# SETTLERS RANCH

## Filing No. 2C

# Construction Drawings

## El Paso County, Colorado

GRADING & EROSION CONTROL PLAN (CENTER)

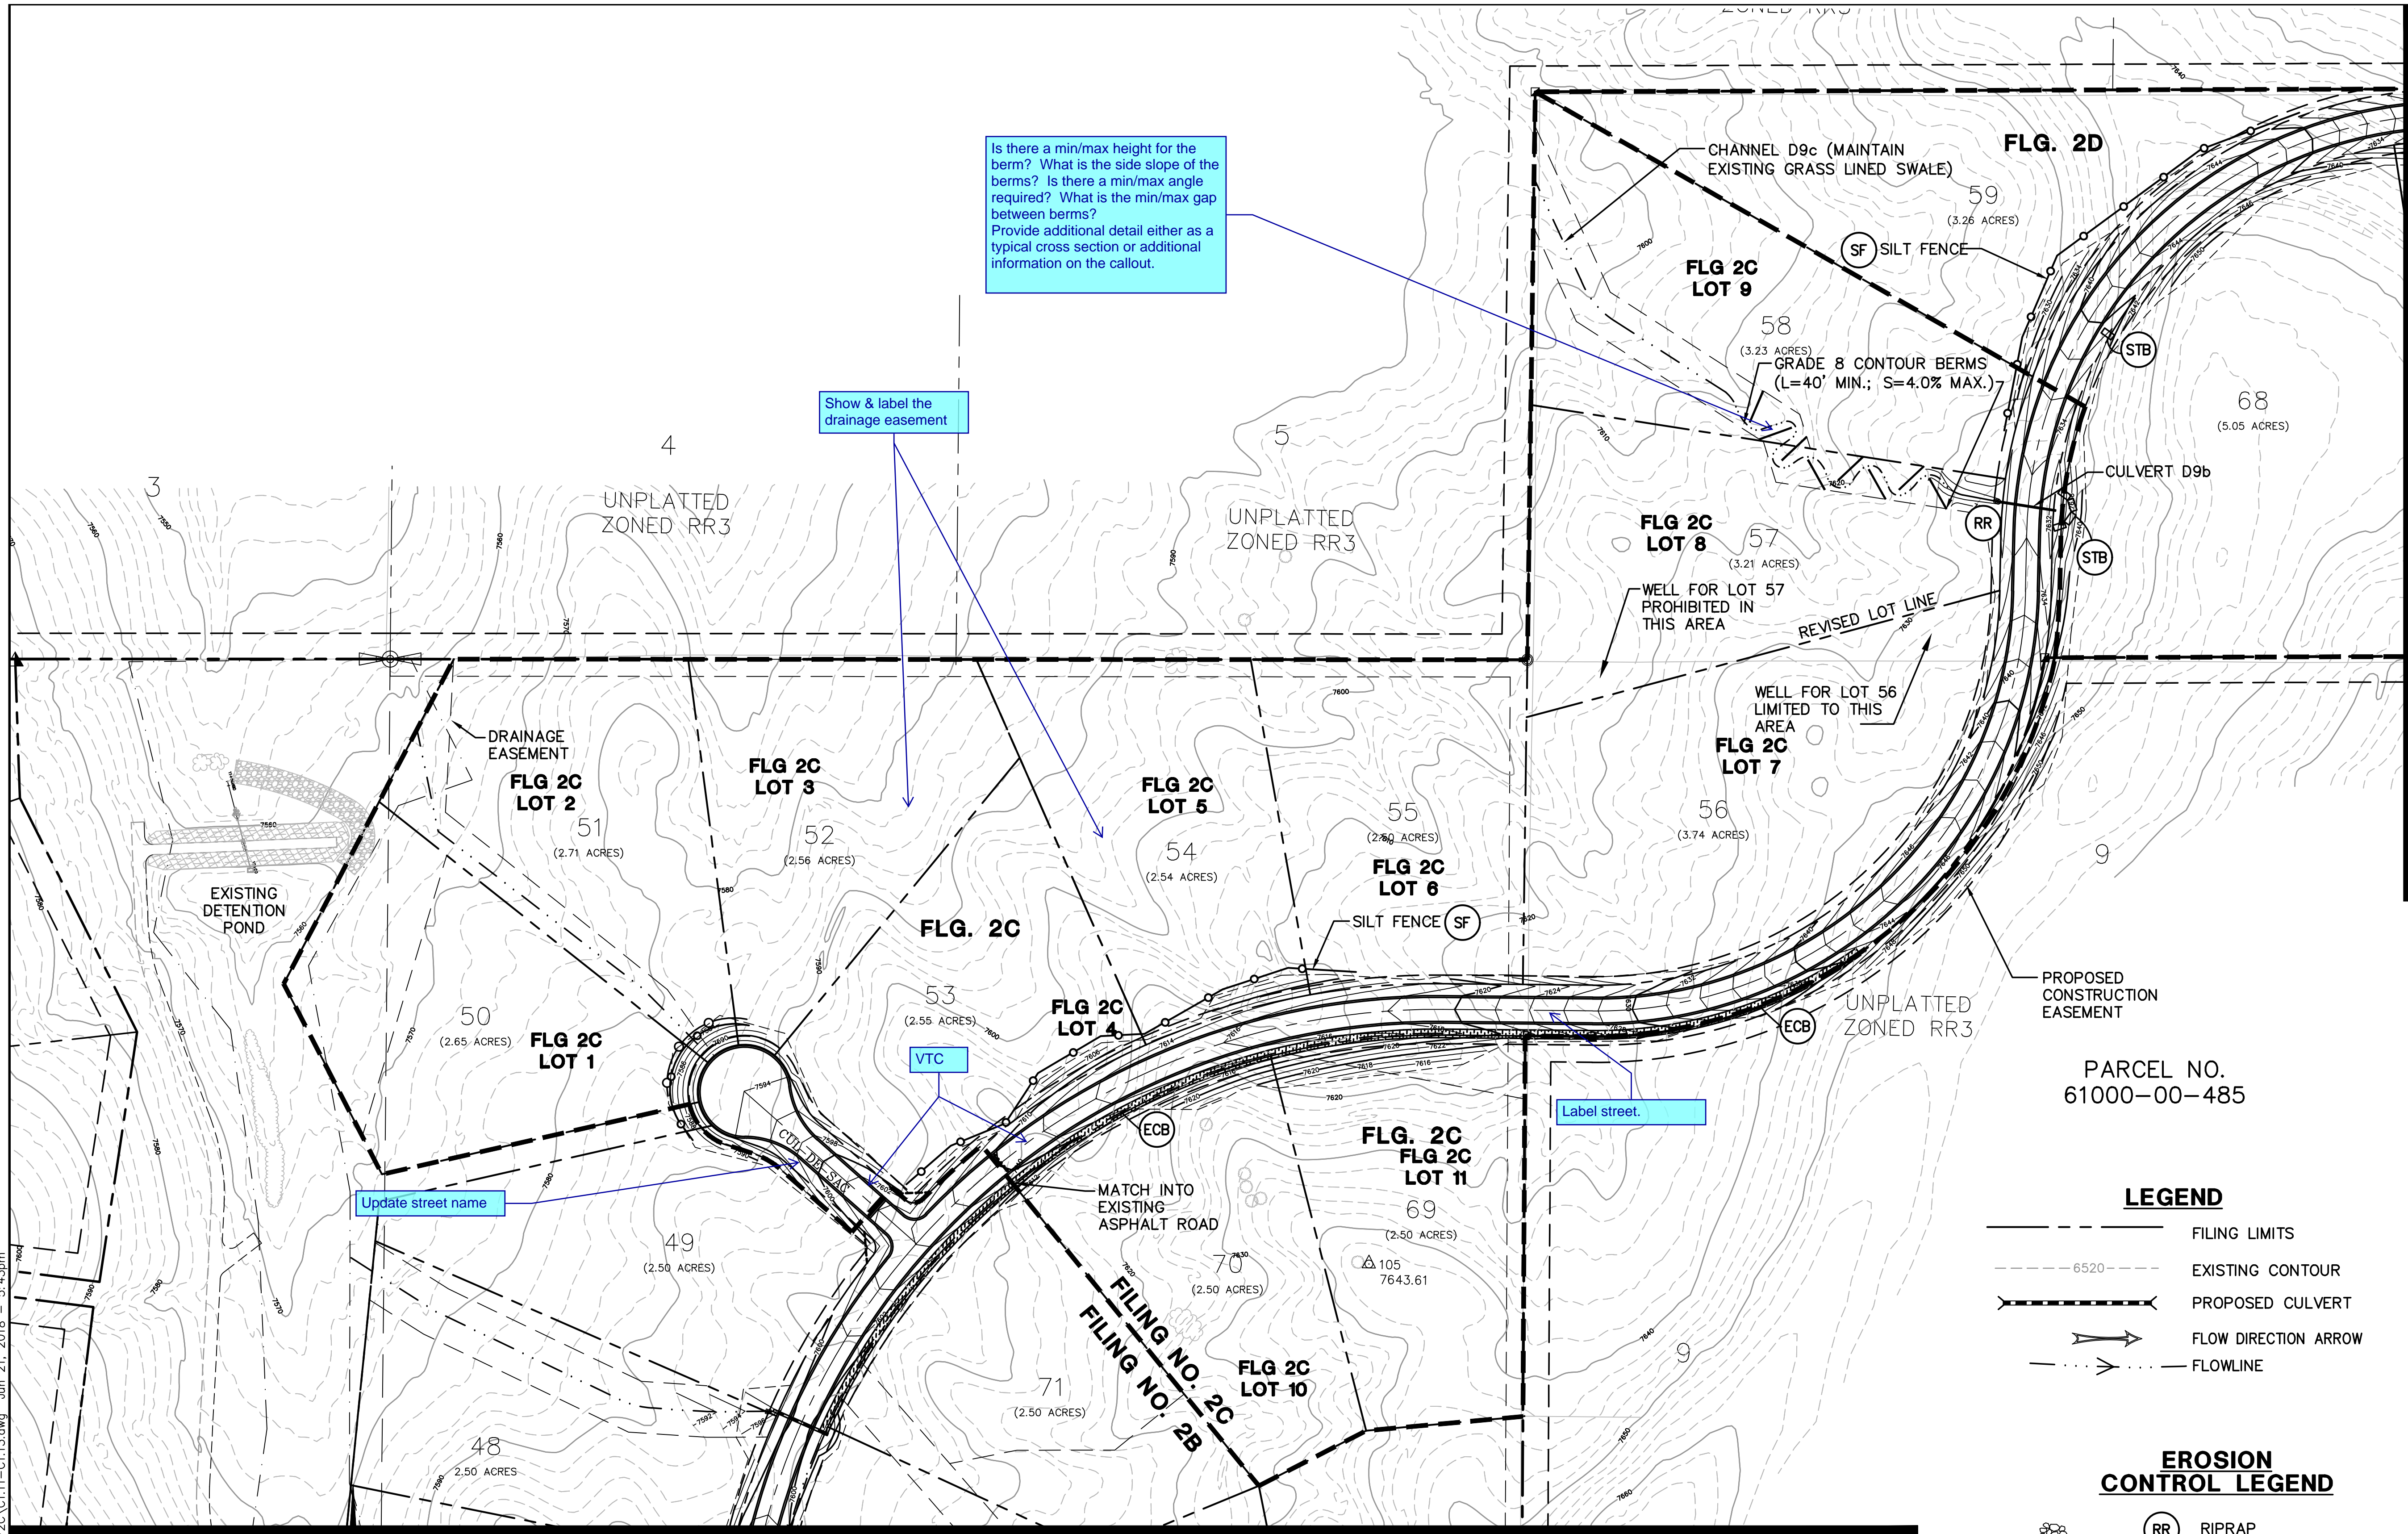
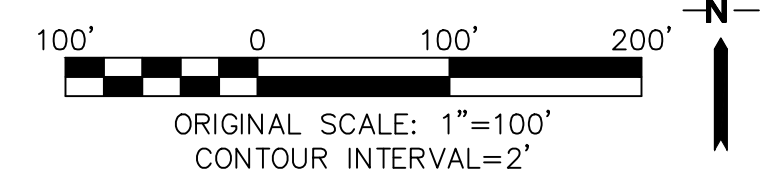
Is there a min/max height for the berm? What is the side slope of the berms? Is there a min/max angle required? What is the min/max gap between berms? Provide additional detail either as a typical cross section or additional information on the callout.

Show & label the drainage easement

Update street name

Remove match line reference or update the reference to identify the construction drawings for filing 2B

## TYPICAL SECTIONS AND DETAILS

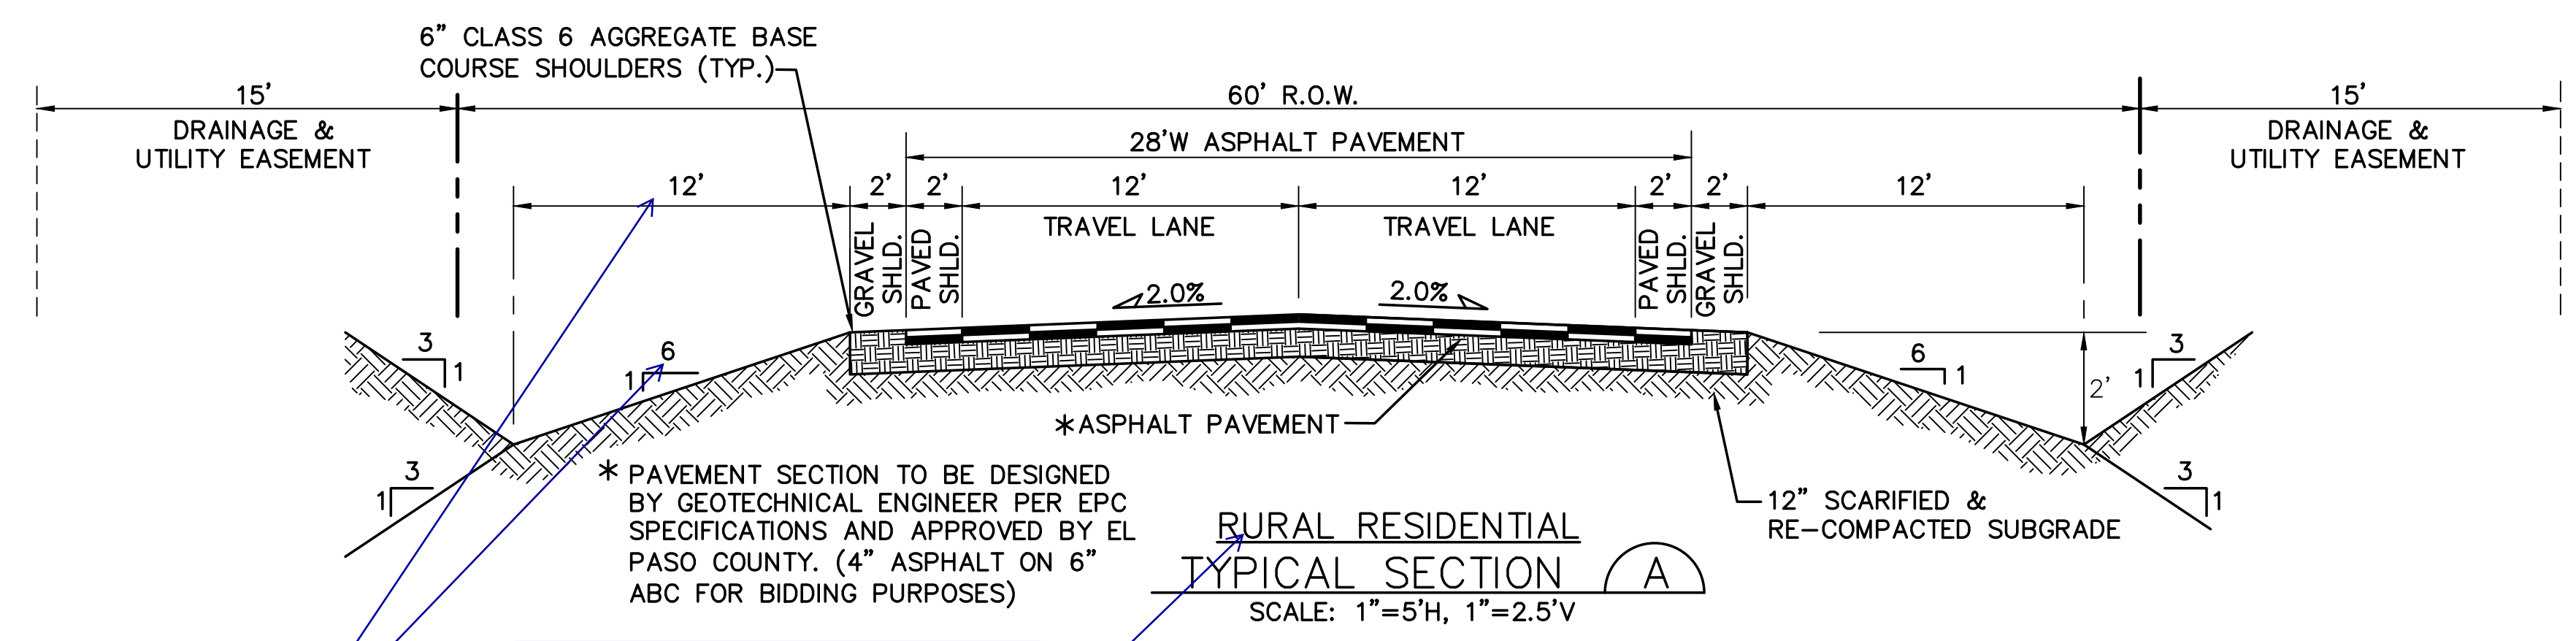
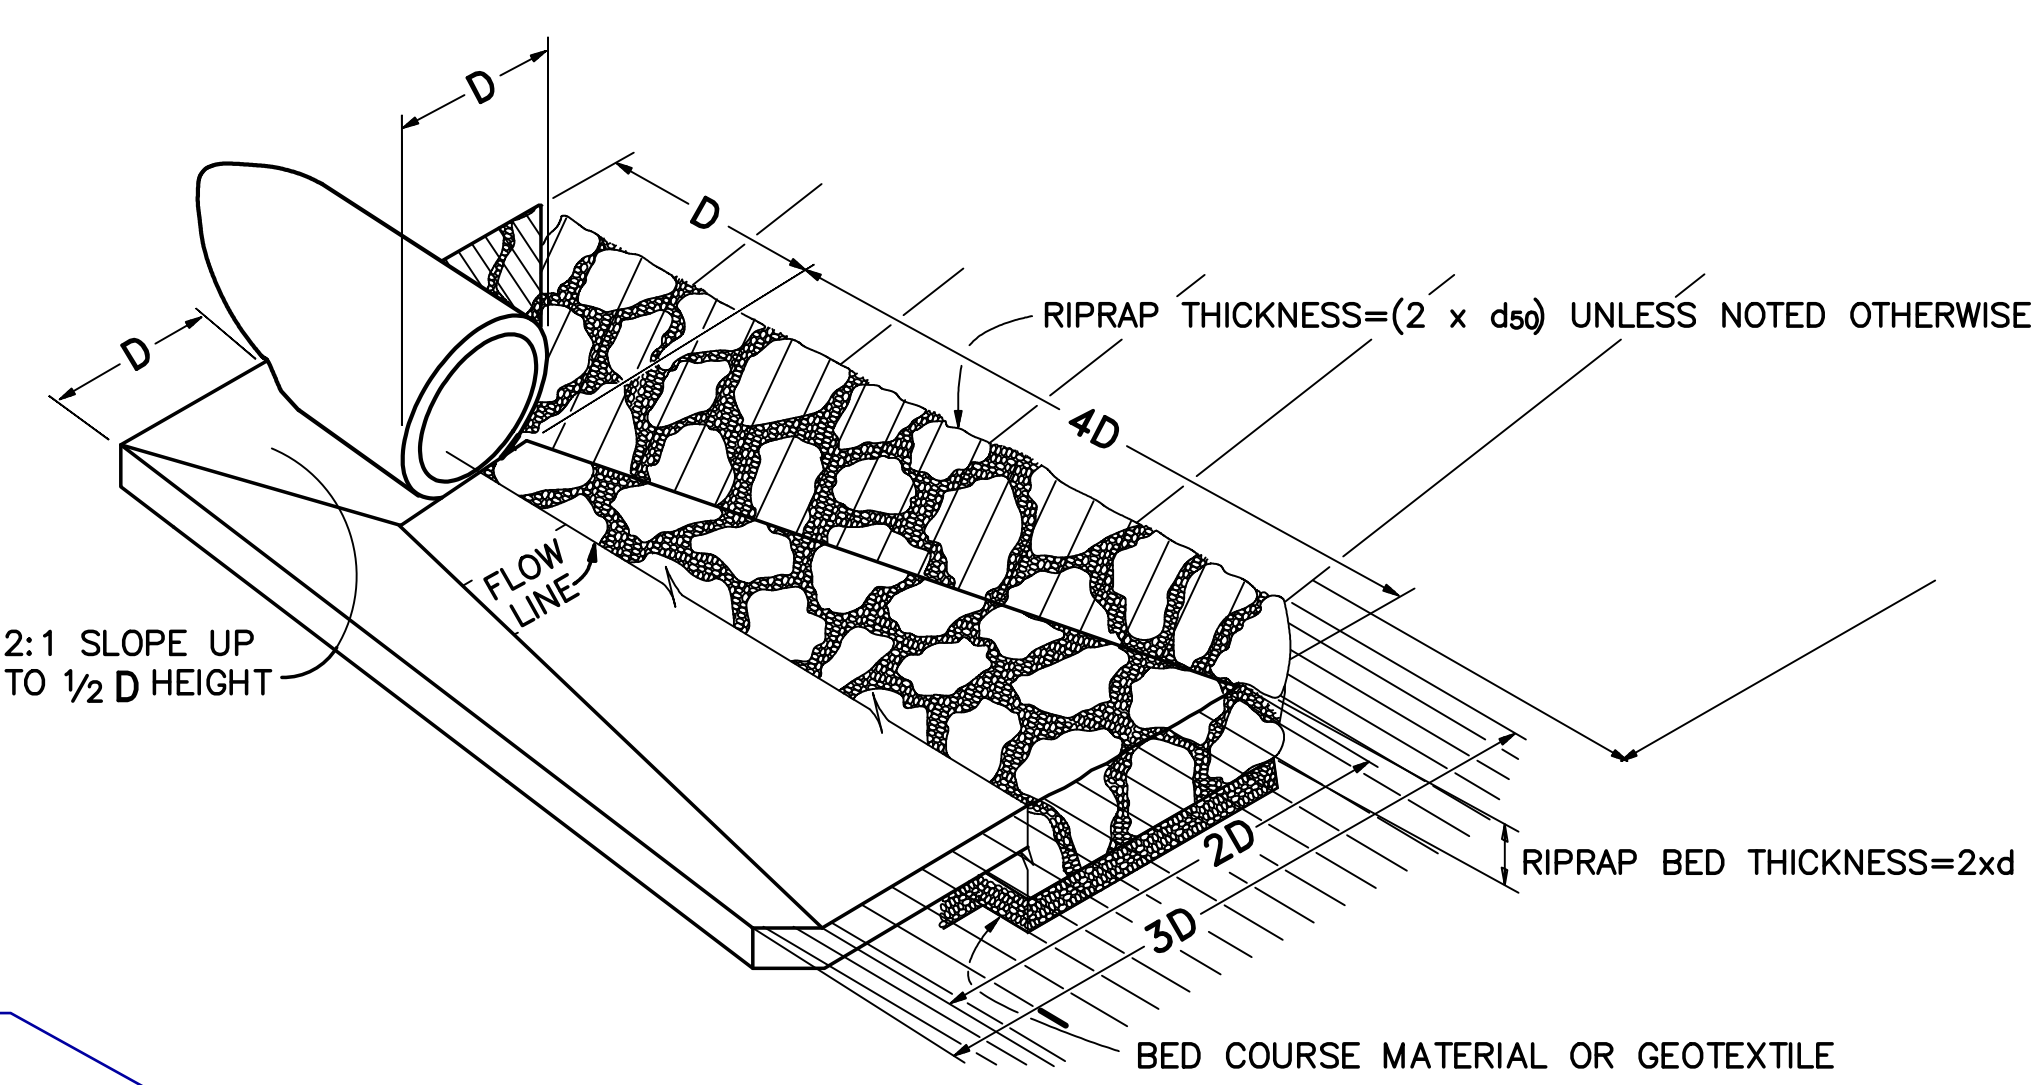
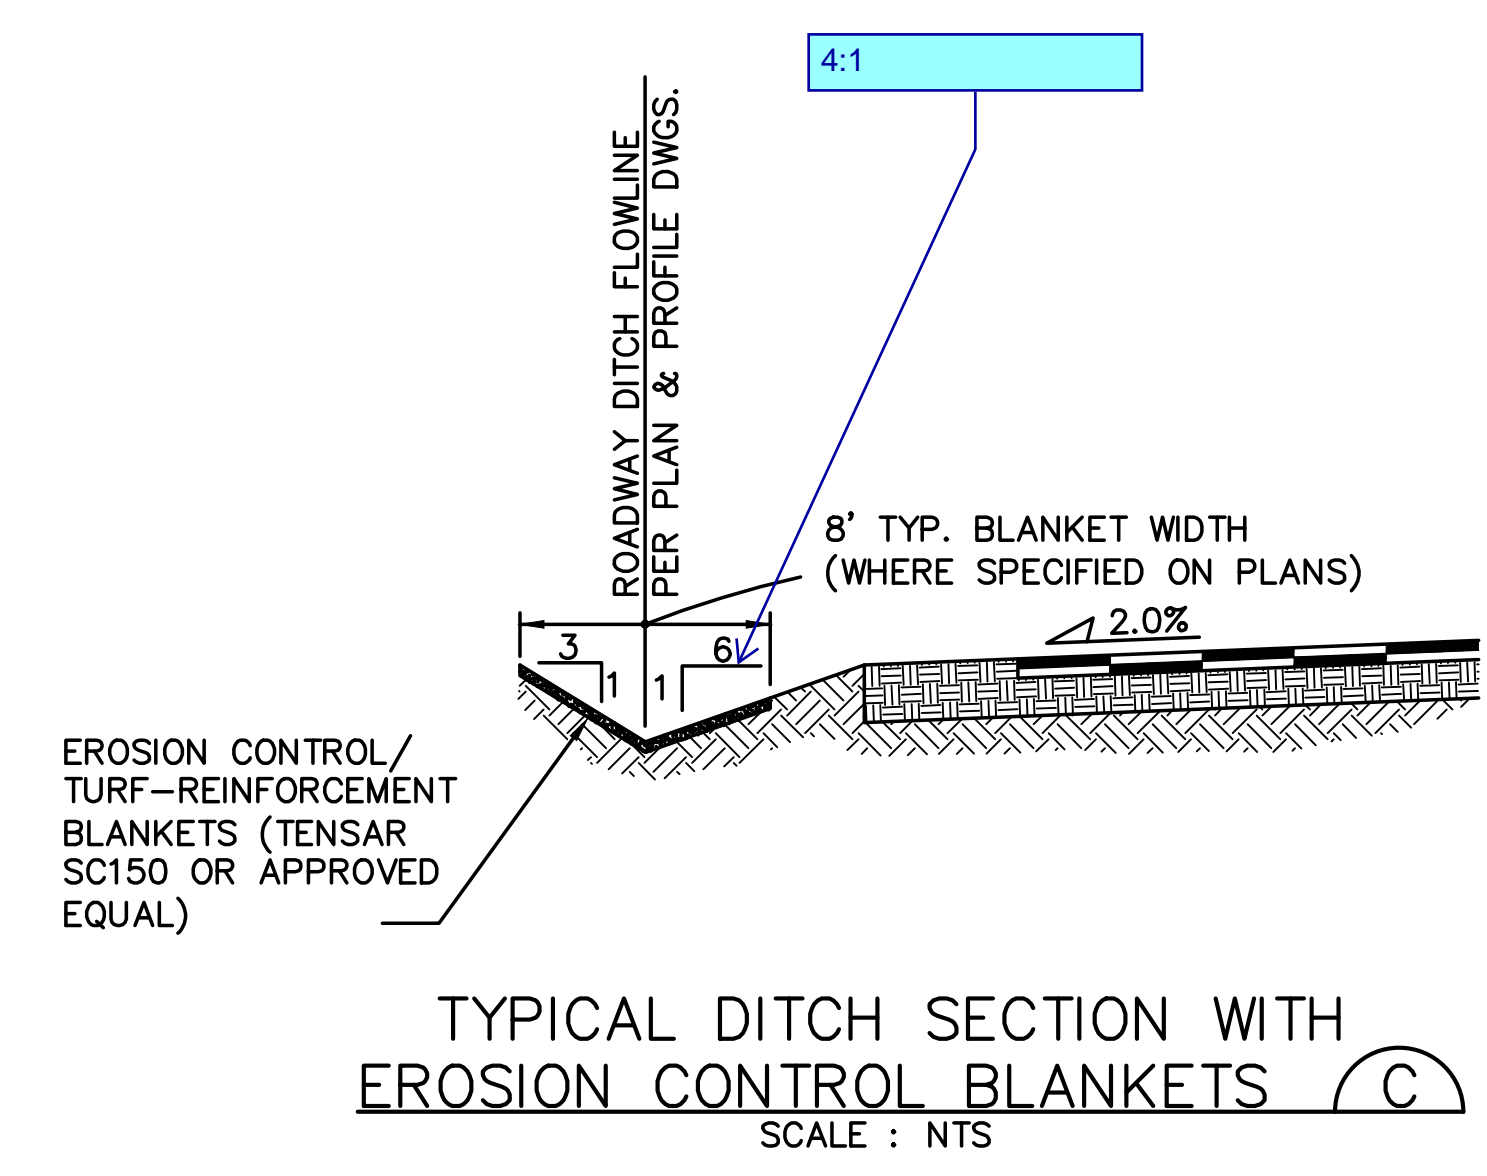
Rural Local has a 4:1 slope, 10' from the gravel shoulder. Revise or submit a deviation request.

Change to match the EPC standard roadway classification. "Rural Local Roadway" and note the roads this cross section applies to.

Update the table with requirements for Culvert D9b.
